**Re: Seacoast Reliability Project - SEC Docket 2015-04
Notification of Minor Construction-Related Changes**

SEACOAST RELIABILITY PROJECT

Table 1. Seacoast Reliability Project wetland impact changes due to construction modifications.

Revised Environmental Maps

Map 6 of 31
7/16/18

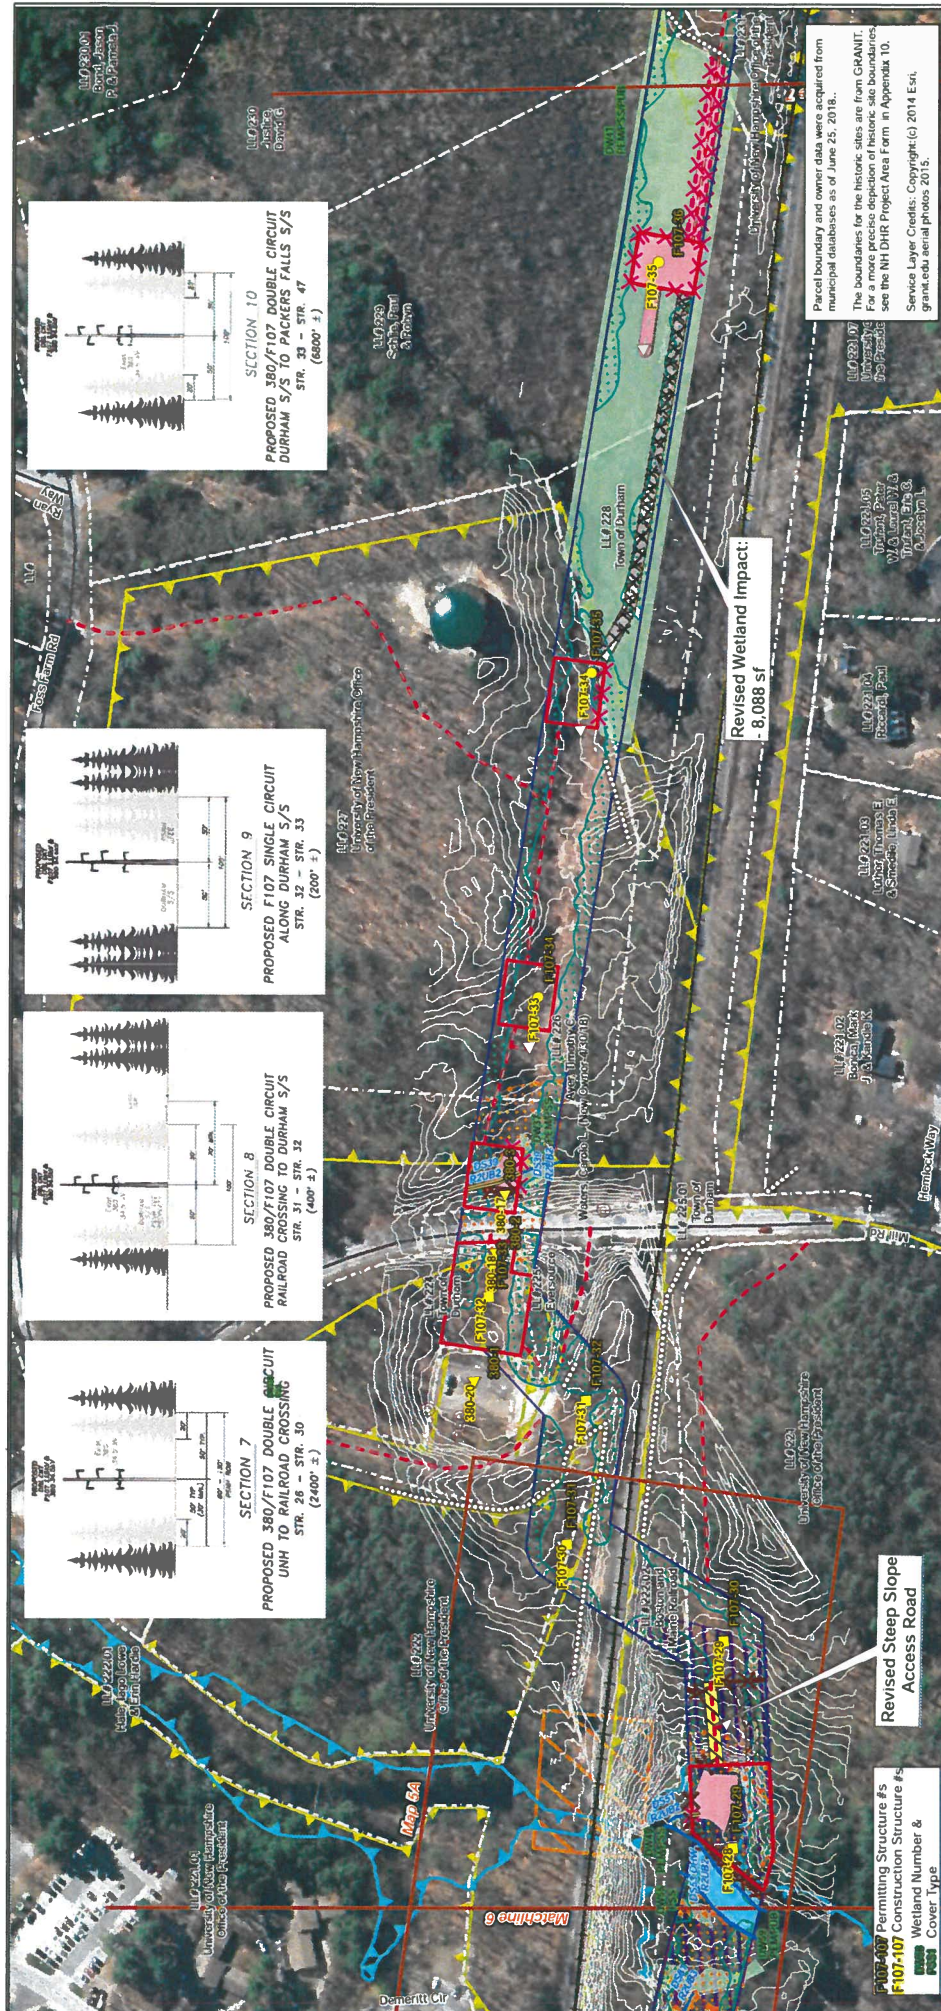
- Structure 24, Map 6. The contractors have removed the existing utility pole in Wetland DW 65 from the timber work pad. This change has resulted in an additional 252 square feet of temporary impact due to the need to briefly lay timber mats to reach the pole. The change was necessitated to avoid overhead wires from adjacent utilities, and minimal disturbance to the upland and parking area.

Map 7 of 31

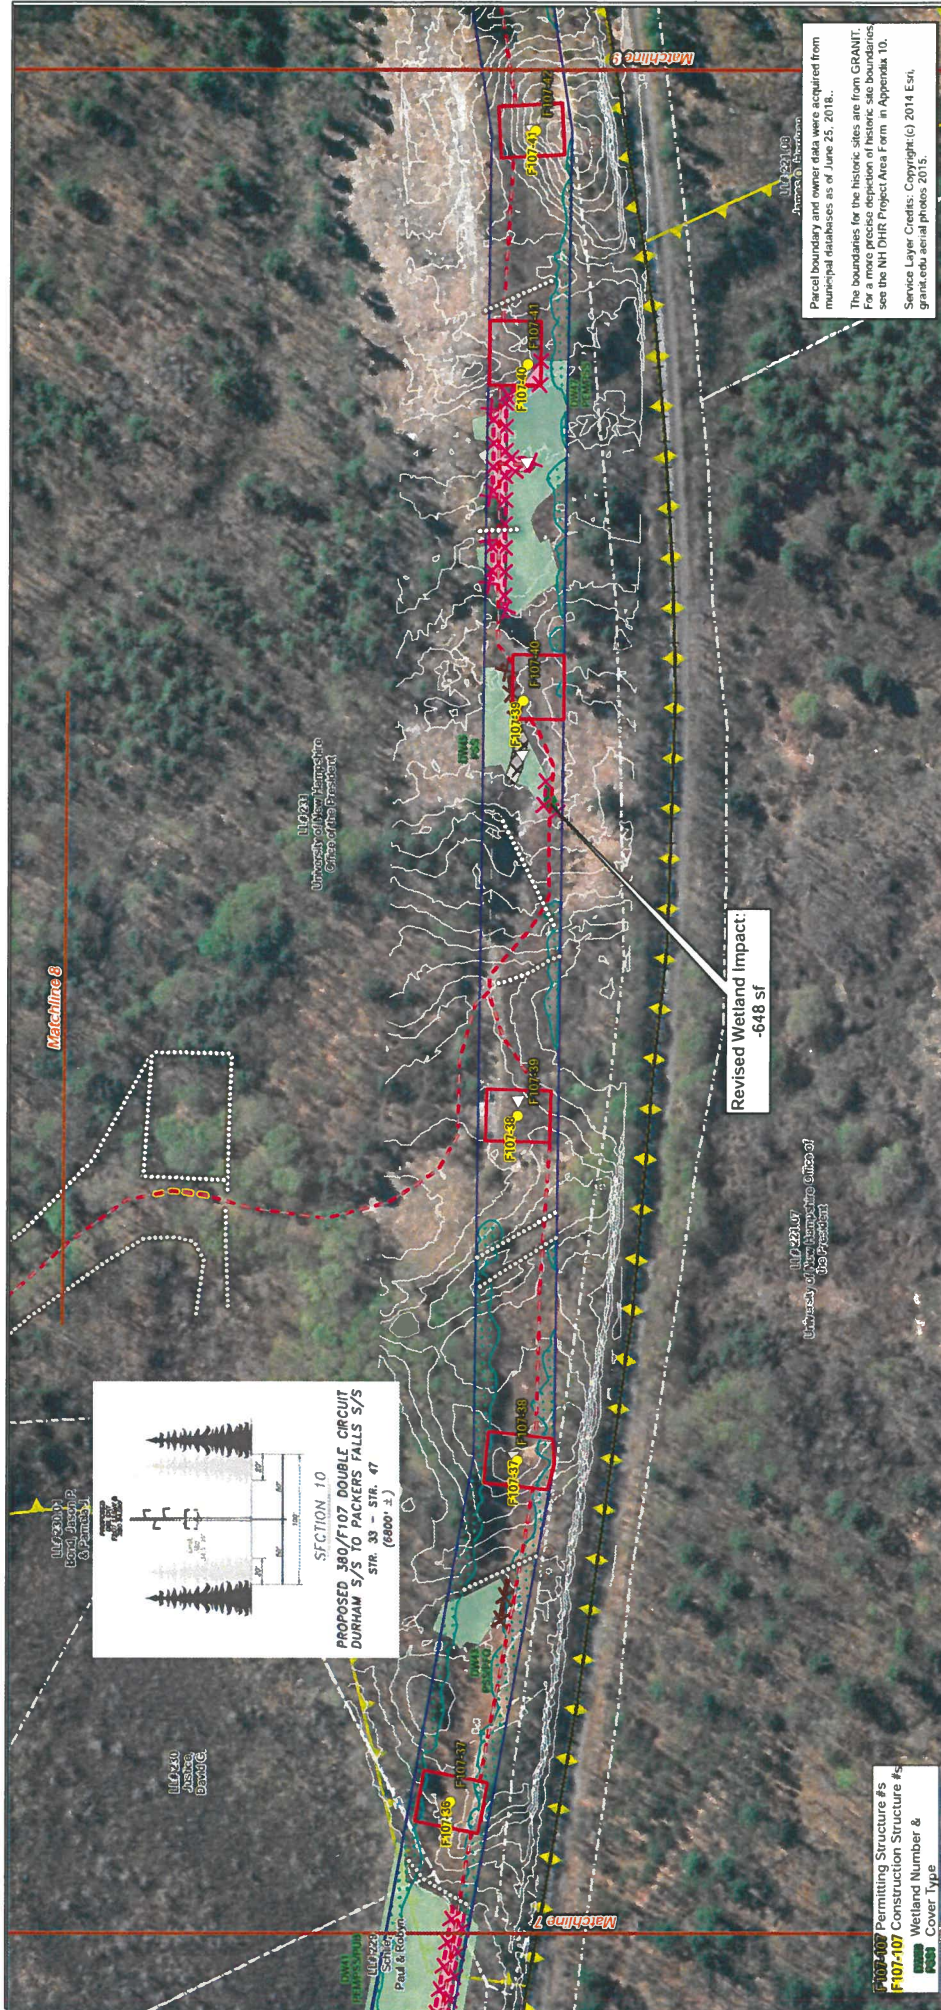
- Structures 28-29, Map 7. The contractors recommended the shift in the access road from the western edge of the right-of-way (ROW) to the center. They felt it was a safer route because it eliminates a side-slope, which was a concern for heavy equipment (concrete trucks needed for pouring Structure 28). No additional impacts to wetlands or other natural resources results from the change. Steep slope BMPs were implemented, including timber mats on the slope, silt fence and straw bales to stabilize side slopes and seeding with upland conservation mix to re-establish vegetative cover on exposed soils.

- Structures 34-35, Map 7. The Town of Durham allowed Eversource to access the ROW from the water tower east of Structure 34, which eliminated the need for wetland access across DW41. Temporary wetland impacts decreased by 8,088 sf to DW 41.

Map 8 of 31

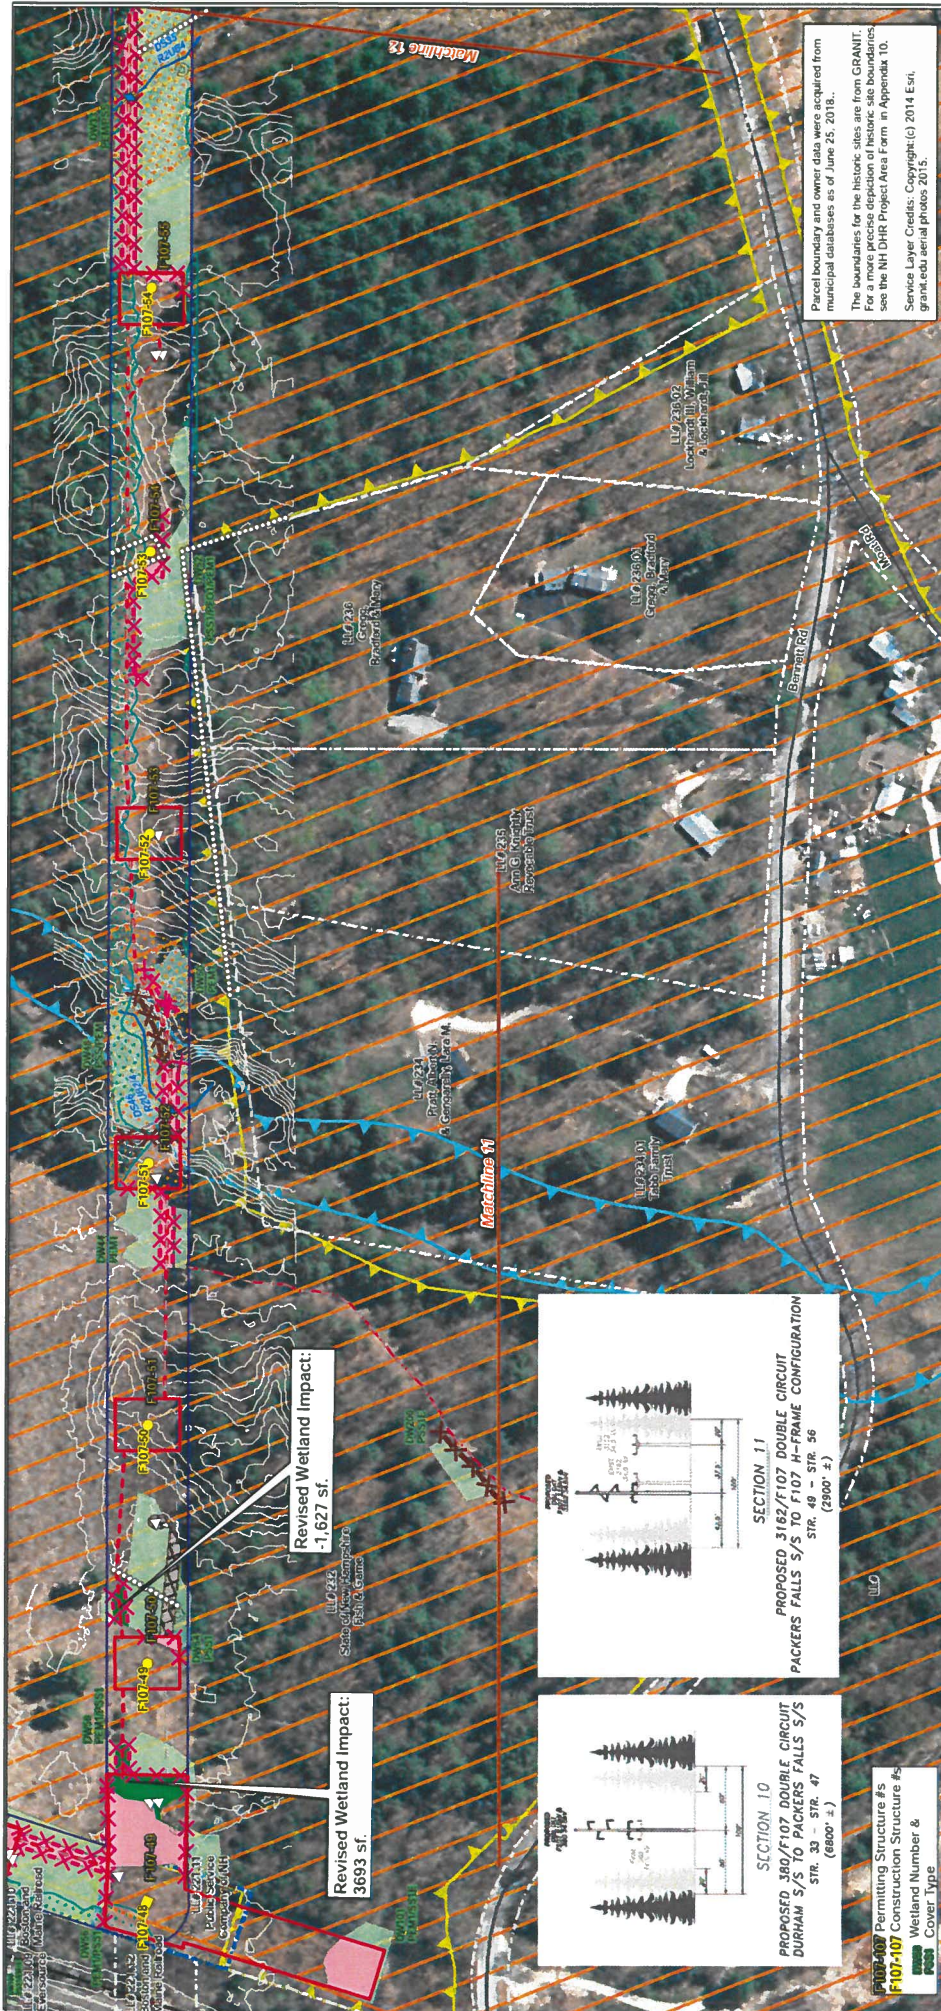
- Structure 39, Map 8. The access road was shifted to the west to use a more complete breach in the stone wall, and further reduce wetland impacts. This change results in a decrease of 648 sf of temporary wetland impact to DW 46.

Revised Wetland Impact:
-648 sf

Map 12 of 31

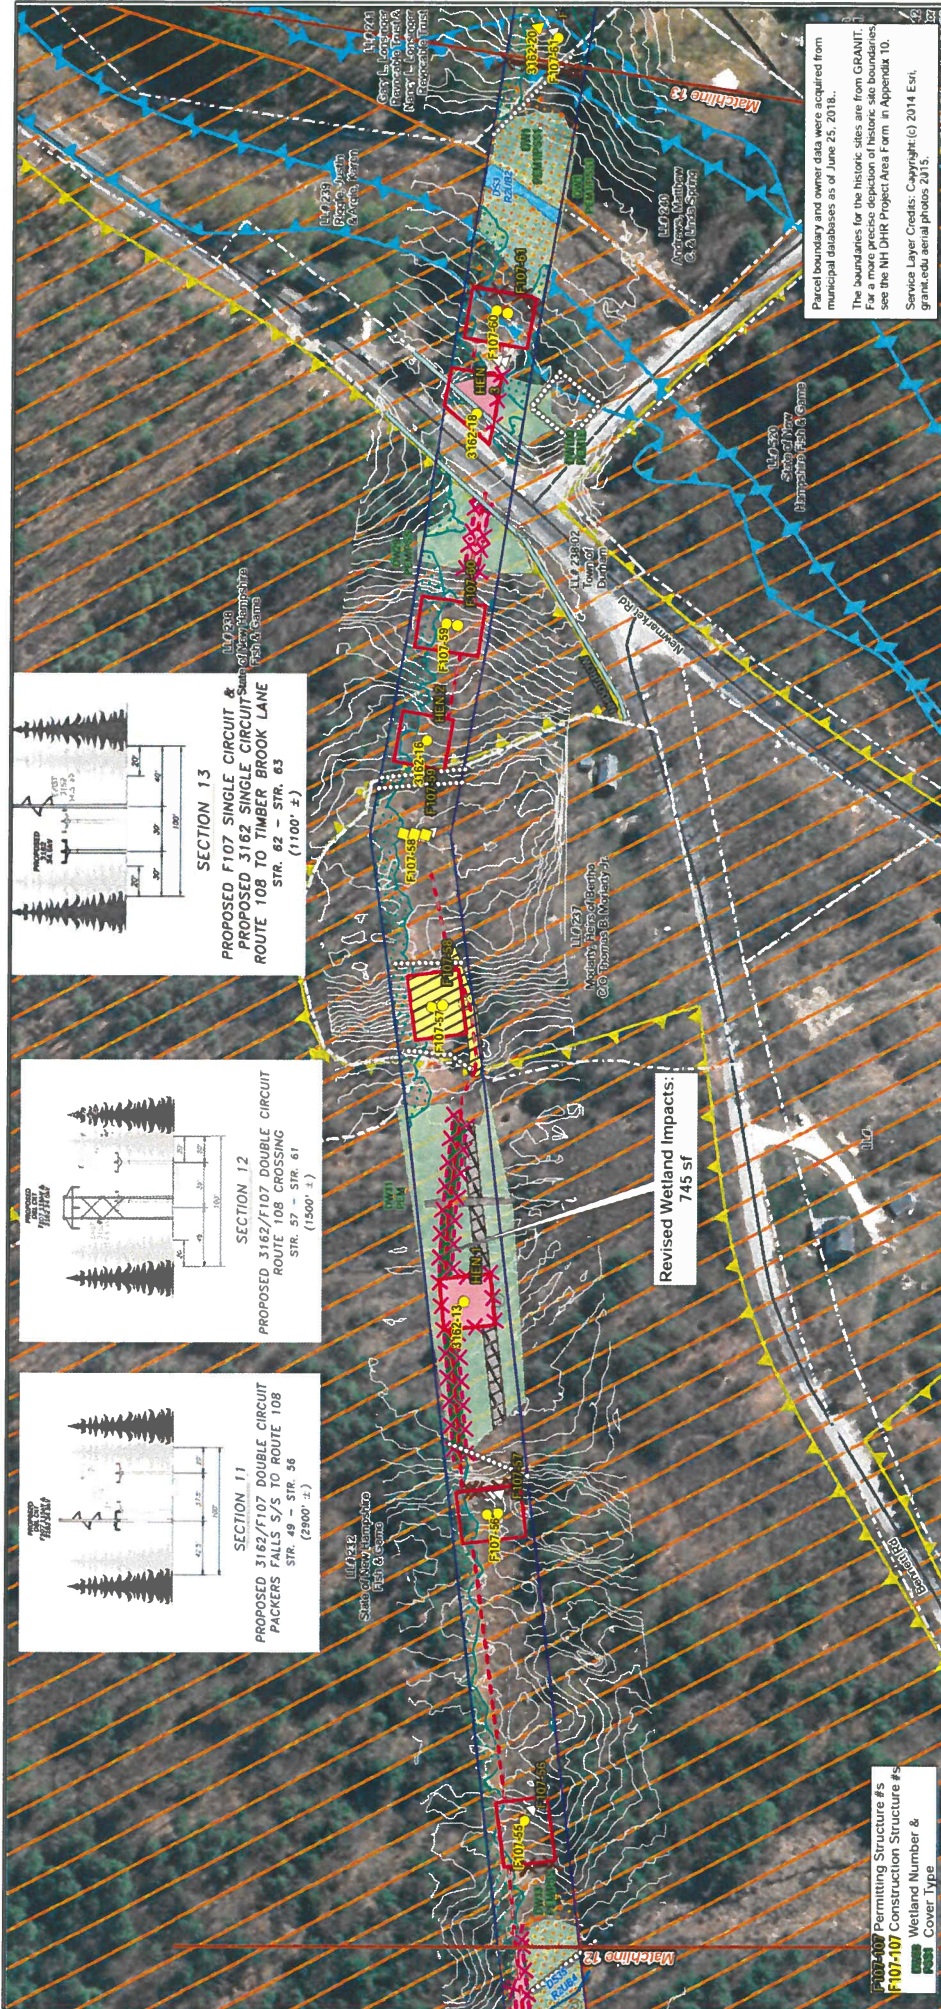
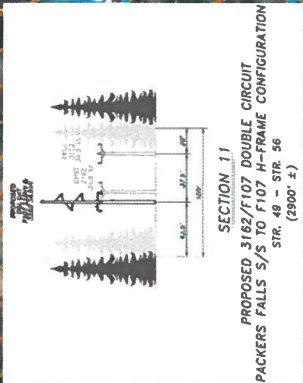
- Structures 48-49, Map 12. Prior to commencing construction, Eversource reflagged the wetland boundaries of DW56. Since the original delineation of DW56, the boundaries of this wetland have expanded. Therefore, Eversource used additional timber mats, in accordance with best management practices, to limit potential impacts to the expanded wetland boundaries. In addition, the access road was shifted to the north side of the ROW to allow for easier and safer construction access in this section. These updates result in an increase in 3,693 sf of temporary wetland impact to the newly flagged boundaries of DW 56.

- Structures 49-50, Map 12. The access road was shifted to the north side of the ROW to allow for less disturbance/avoidance of a stone wall, to reduce temporary wetland impacts. This change results in a decrease of 1,627 sf of temporary wetland impact To DW 54.

Revised Wetland Impact:
-1,627 sf.

Revised Wetland Impact:
3693 sf.

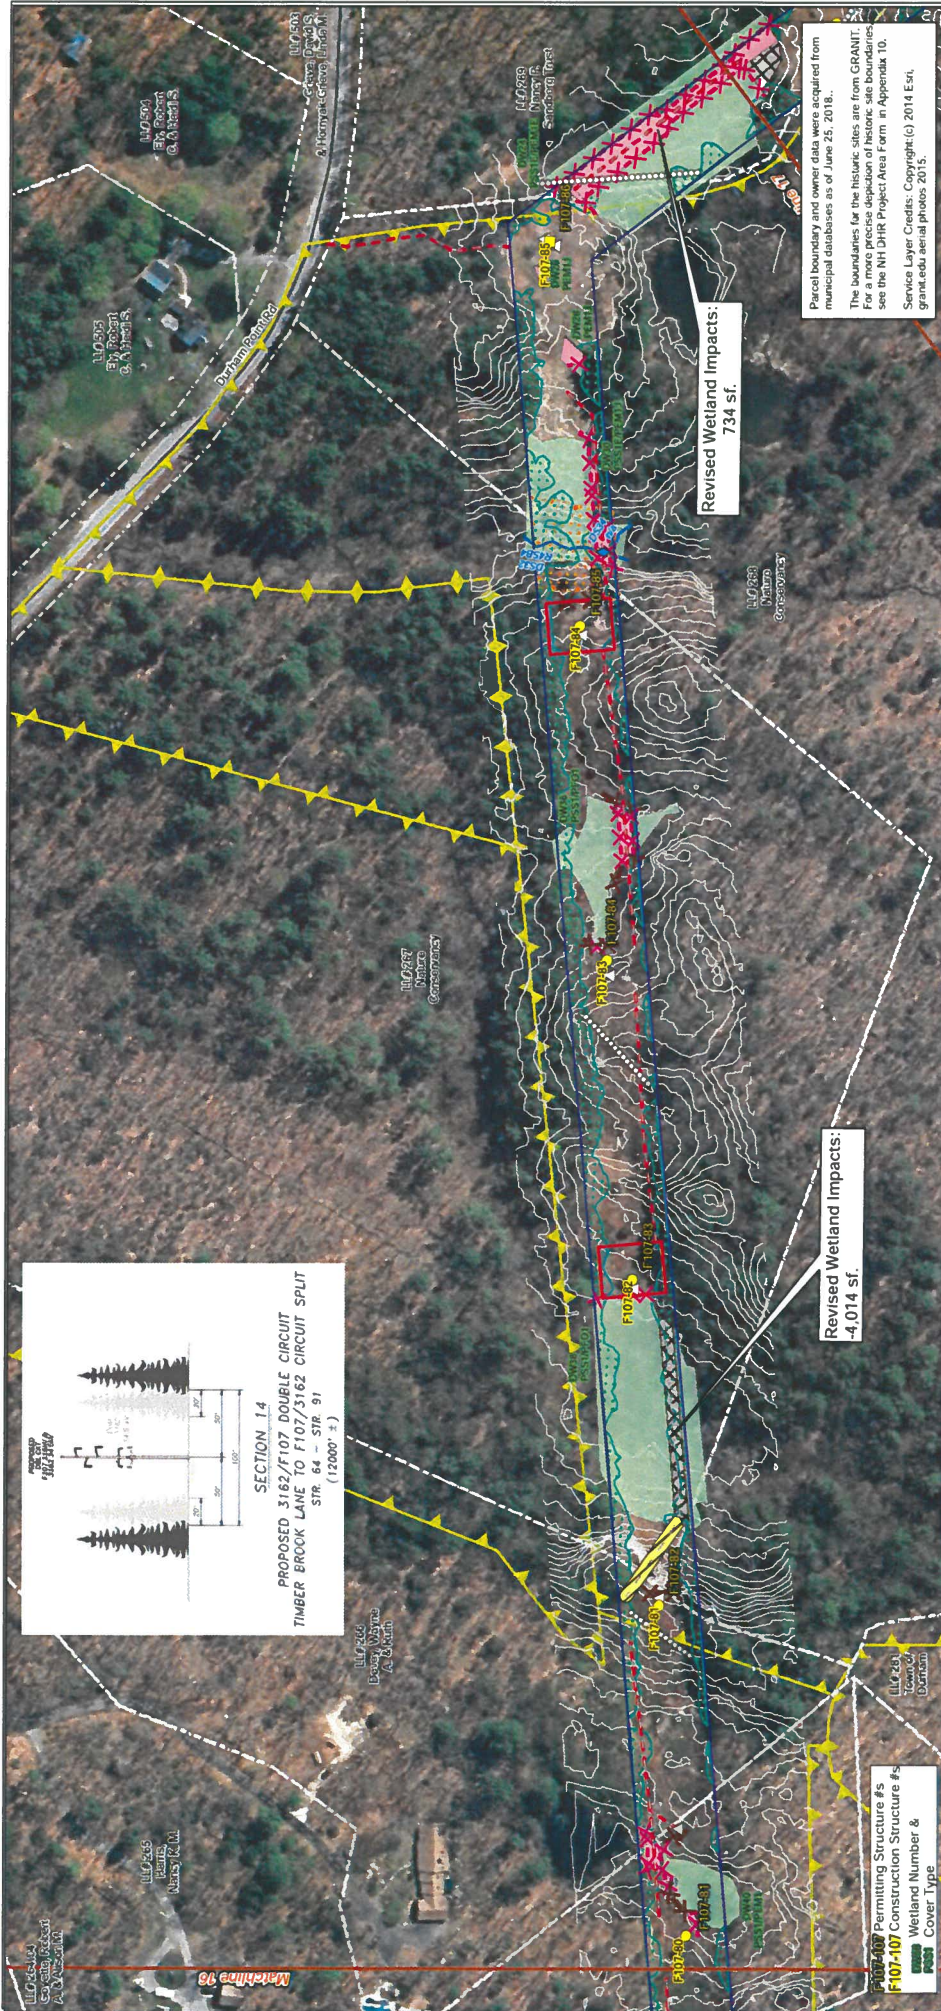
- Structures 56-57, Map 13. The access road was shifted to the north to access an existing breach in the stone wall, and avoid a ledge outcrop on the slope. This change resulted in an increase in 745 sf of temporary wetland impact to DW 31.

Revised Wetland Impacts:
 745 sf
